Item ID: D206-667-207BL

Item Name: Aft Mid Height Crosstube 206L/L1/L3/L4, Blue

DART AEROSPACE LTD HAWKESBURY, ONTARIO, CANADA	
DRAWING NO. D206-667-247	REV. A SHEET 1 OF 4
TITLE CROSSTUBE ASSY (206L MID AFT)	SCALE NTS

DRAWING NO. D206-667-247	TITLE CROSSTUBE ASS'Y (206L MID AFT)	REV. A	DART AEROSPACE LTD ENGINEERING ORDER	D.E.O. NO. D206-667-247-A-1	SHEET NO. SHEET 1 OF 1	SCALE NTS
DRAWN 92	CHECKED ASS	MFG. APPR. KJ	APPROVED JMP	DE APPR. H		
DATE 11.07.15	DATE 11.07.20	DATE 11.07.21	DATE 11/07/21	DATE 11.7.21

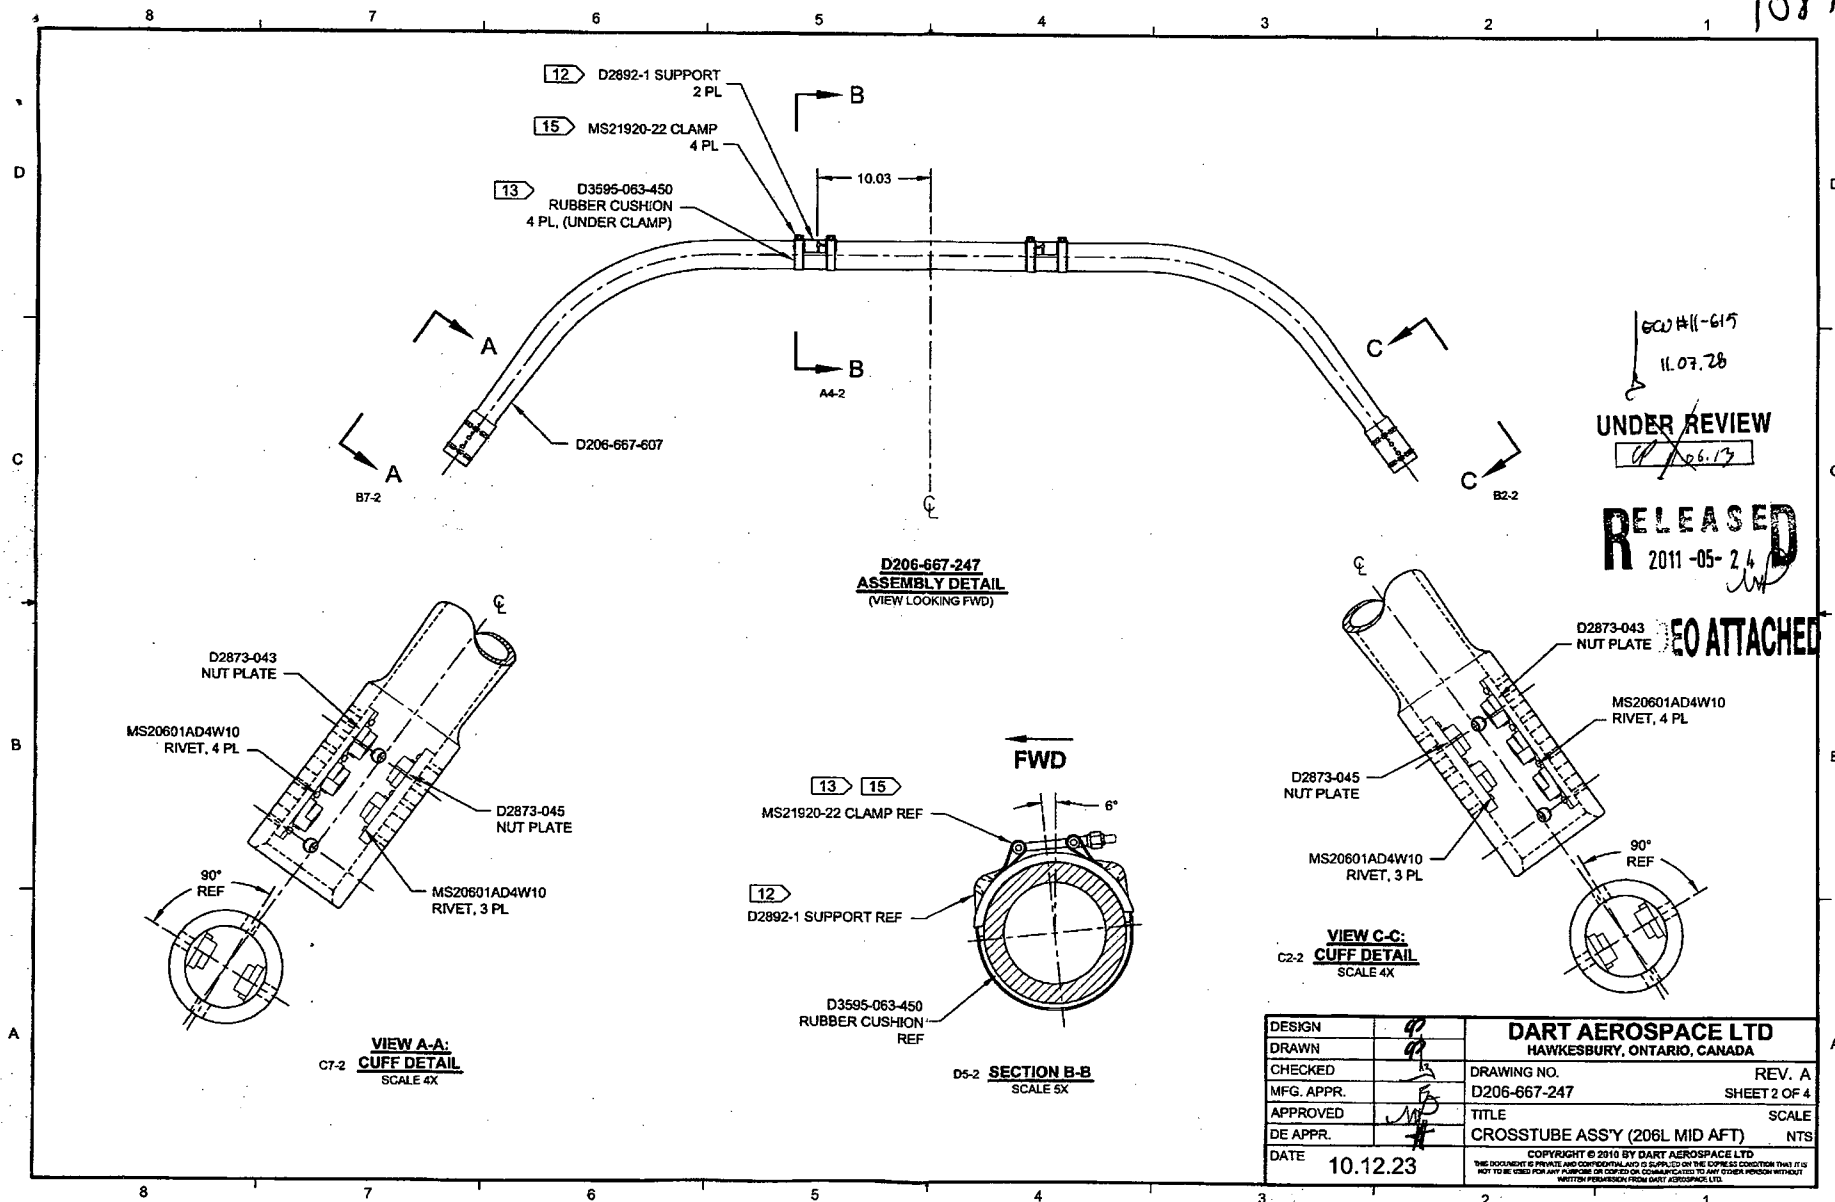
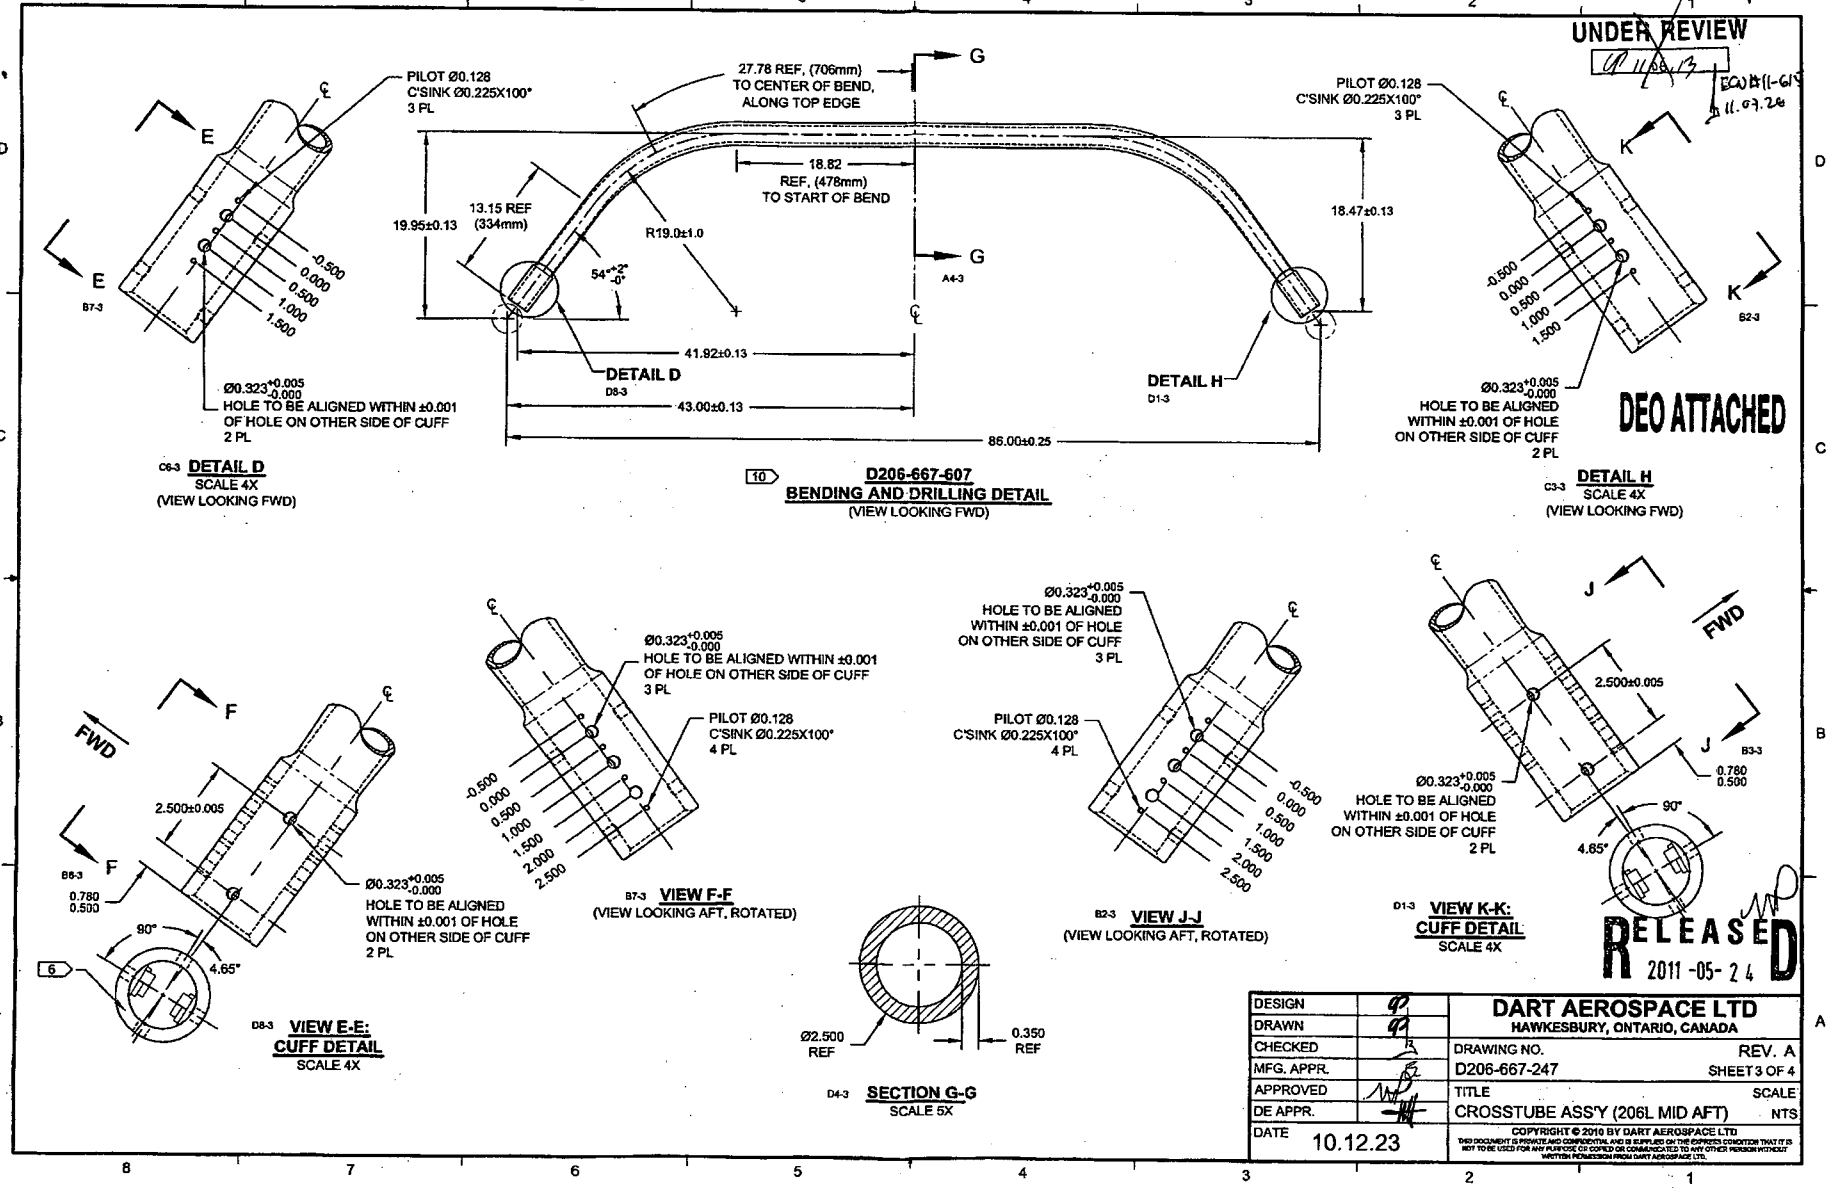
REPLACE MAGNOBOND WITH PROSEAL.

NOTE 12 & 15, SHEET 1 IS AMENDED AS FOLLOWS:

- 12) TO INSTALL D2892-1 SUPPORT: ABRABE MATING SURFACE OF SUPPORT AND CROSSTUBE WITH 180-GRIT SANDPAPER AND REMOVE RESIDUE WITH MEK (OR EQUIVALENT). APPLY A 0.04" TO 0.07" THICK LAYER OF PROSEAL 890 CLASS B-2 (OR AMS-S-8802 CLASS B-2) SEALANT TO MATING SURFACE OF SUPPORT.
- 15) TORQUE CLAMPS 80 TO 100 IN-LB. ENSURE AT LEAST 1.5 THREADS SHOWING IN SAFETY AND THAT NUT HAS NOT BOTTOMED-OUT AFTER TORQUING. **PRIOR TO PACKAGING, RE-CHECK TORQUE ON CLAMPS AFTER PROSEAL 890 SEALANT HAS CURED FOR 72 HOURS.**
